North Potomac Yard Small Area Plan Advisory Group

Report to Parks and Recreation Commission

July 21, 2016

CHARRETTE OPTION ONE: METRO LANDING

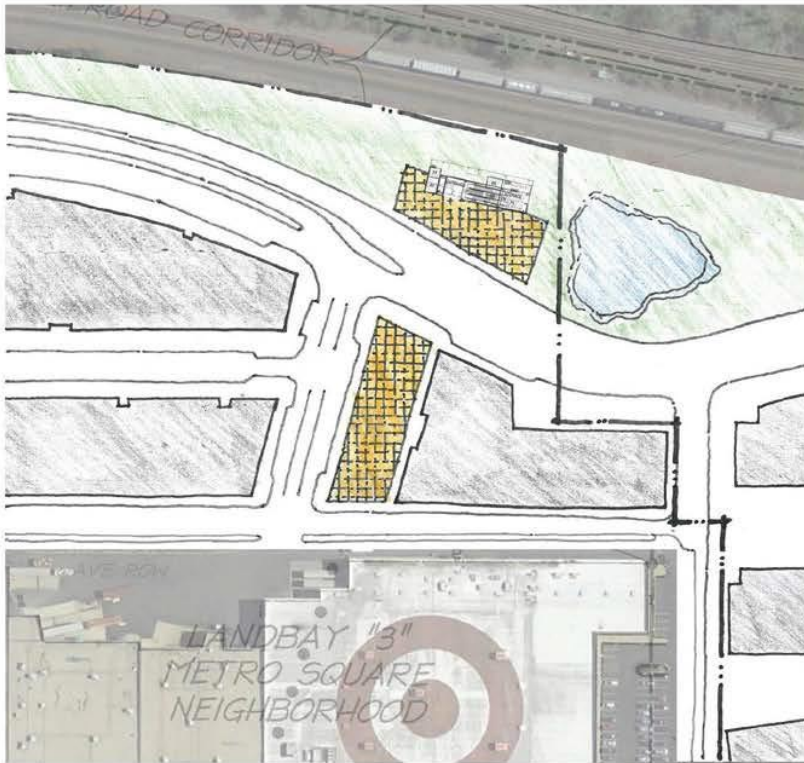
- This option created a space where Metro was divorced from the development and seemed to be just dropped in the park. There was no integration with real public space or the park.

- Metro seems isolated across Potomac Ave (1)
- Potomac Ave is very wide (1)
- Difficult pedestrian experience getting across Potomac Ave (very wide, need to wait for light)
- Yes, closer to BRT, but concern would be with pedestrian crossing the right-of-way
- Like BRT dropping off more central to the development (Opt. 2)
- Like pond next to plaza (Opt. 2 South)
- Plaza could be done well in Option 1

- Metro is divorced from development
- Least pedestrian experience
- Less cohesive plaza design
- Plaza feels broken up/integrating the two plazas a challenge
- BRT connection is strong
- Connectivity to Metro strong, weak for connectivity to neighborhood

- Pedestrian access from BRT/Metro is jumbled
- BRT arrives closest to Metro of 3 options
- Crossing Potomac Ave-pedestrian nightmare/difficult, speed of vehicles

CHARRETTE OPTION TWO: SOUTH METRO LANDING

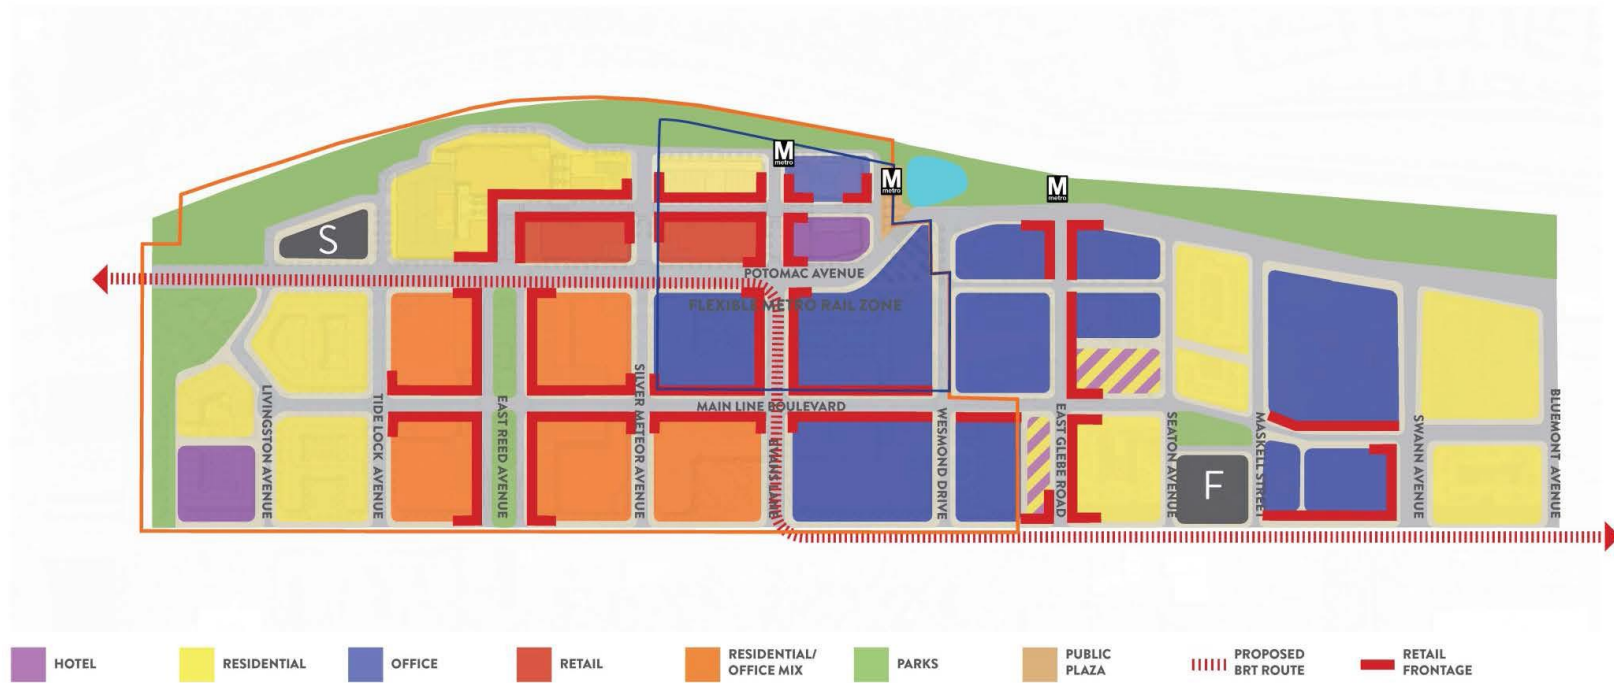
- This option brought more of the development up into the park and created a closed-off area for the Metro. There did not seem to be much of a benefit for the development or for the park.

- South Entrance-Less distance on bridge
- Feels like a bottleneck coming off the metro
- Awkward relationship to everything else
- Like pond next to plaza
- Ability to circulate vehicles

- Plaza all in one piece
- Activates the plaza
- Relationship to adjacent uses is strong
- Constraint - How attractive will the south pond be?
- Lower than 2N, 2N better connected

- No visual connection to Metro from BRT
- Very tightly constrained
- Seems urban/small-just a stop not necessarily a civic plaza

CHARRETTE OPTION TWO: NORTH METRO LANDING

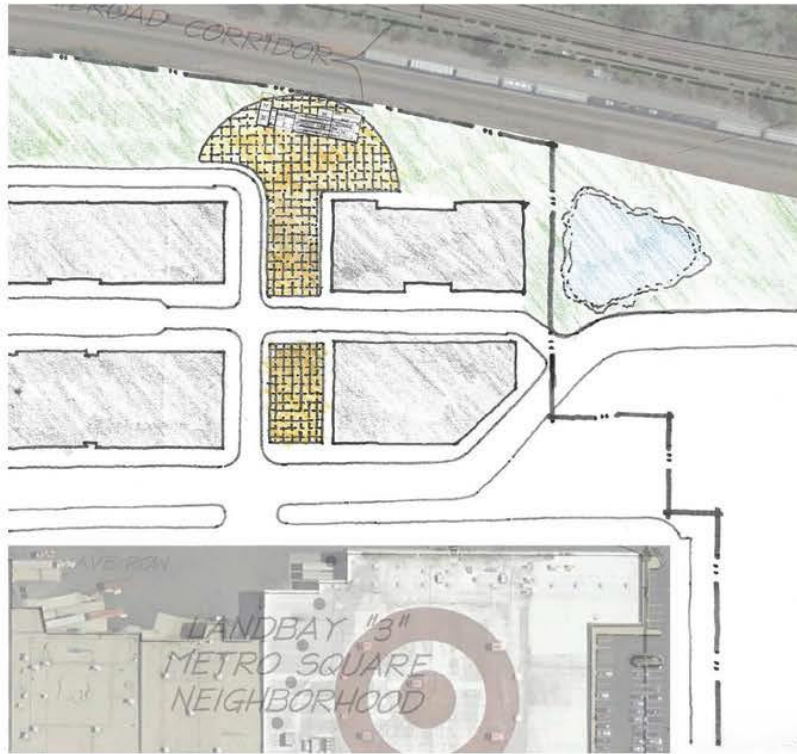
- This option brings Metro closer into the development and allows for some interesting integration with the park.
- This creates the best pedestrian experience and will also allow for some experimentation with the plaza on park land.

- Minimizes width of street crossings (frames pedestrian space)
- North Entrance-Least overlaps. Most office use
- Seems like a good pedestrian experience-terminates vista
- Sensory experience, like way buildings wrap
- Further North, more office workers
- Provides good access between Metro and BRT
- Option to connect to the park
- Nice urban room
- Good visibility coming in
- A little issue with whether there is something to see coming down the middle of the street.

- Buildings can great a canyon effect
- Kind of hidden
- Integrated into the park
- No road around office privatizes park, delineation of office building to park important
- Has strong connection between the plaza, not the road
- Activates and creates a memorable open space
- Potential challenge and opportunity to integrate Metro, park, and plaza
- More fun stuff immediately adjacent
- Breaks distance of two Metro stations

- Visual connection between BRT & Metro
- Comfortable crossing-plaza framed by buildings
- Best pedestrian experience, visual connection from blocks away, spills out into the park
